**Government of Canada  
Existing Building Renovation  
Issue for Tender**  
*Alberta, Canada*

# Addendum No. 2

September 7, 2016

ESK-001

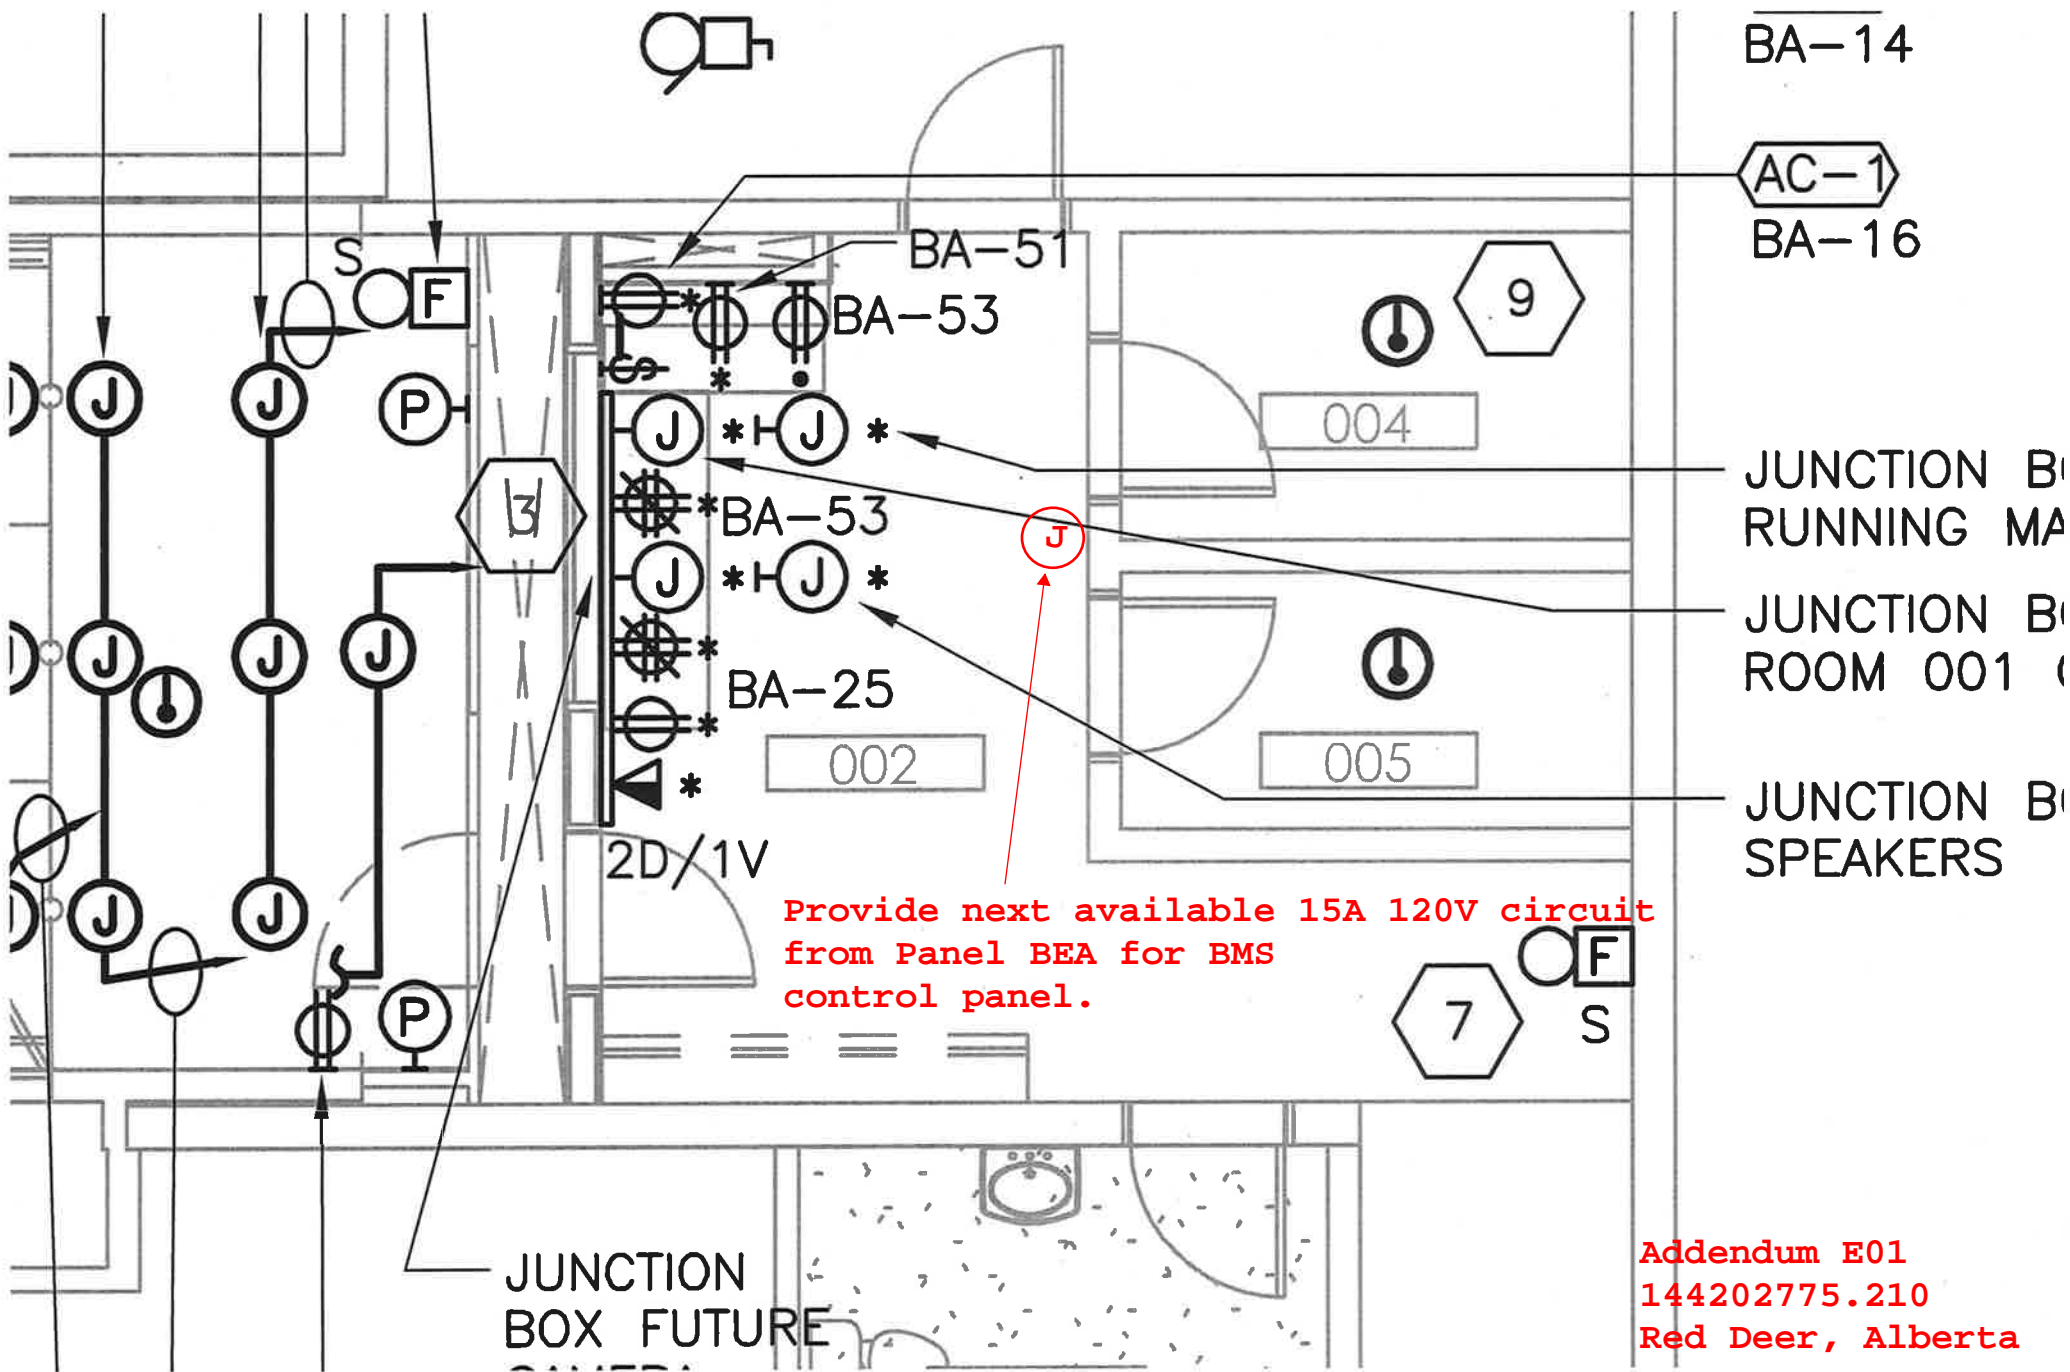
- .1 Refer to IFC drawings E200. An electrical circuit will be required for the new BMS panel. Coordinate with the mechanical contractor for installation. Revise as per SK-1 attached to this Addendum

Provide next available 15A 120V circuit  
from Panel BEA for BMS  
control panel.
